QUESTIONS AND ANSWERS

The following questions have been submitted concerning Bid#172202, Cafeteria Equipment. Questions #2 and #3 indicated a need to amend the bid document. Therefore, Amendment No. #1, Bid#172202 has been issued. All questions received have been answered and are stated verbatim from what was received:

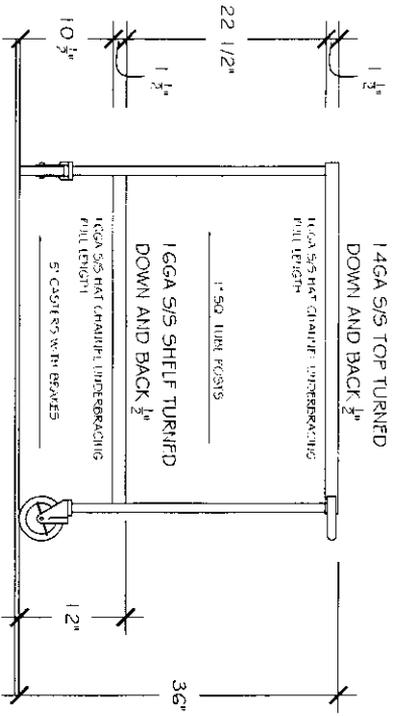
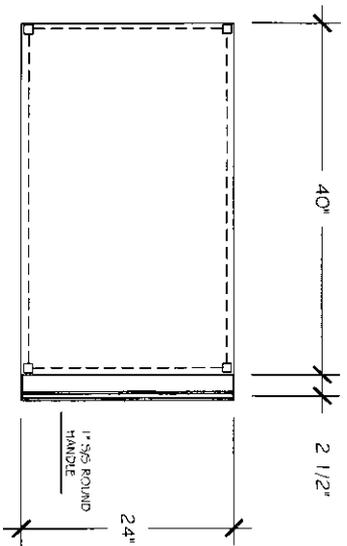
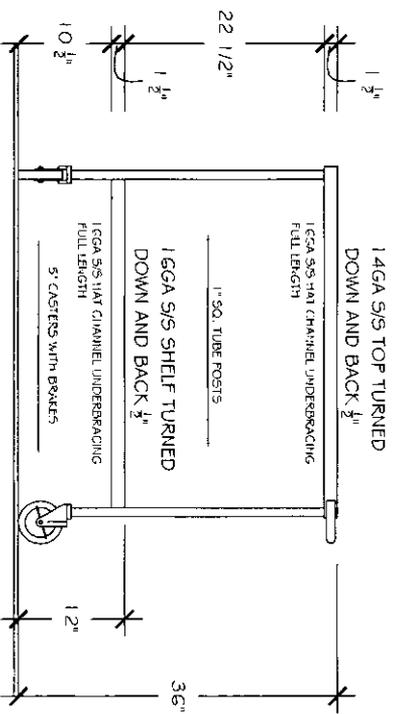
BIDDER QUESTION#4: Item #32 Acceptable brand is listed as a Lakeside #947, Item #33 Acceptable Brand is listed as Eagle #SPECFAB. I am attaching a drawing of (2) custom fabricated carts that are fabricated by a local custom fab shop. I have recently priced these Escambia County Schools, one of which you have purchased from me. Also, according to the fabricator these have been purchased from another vendor as well. Would these carts be acceptable? They are designed and built per the specification.

Yes, the attached drawings are acceptable.
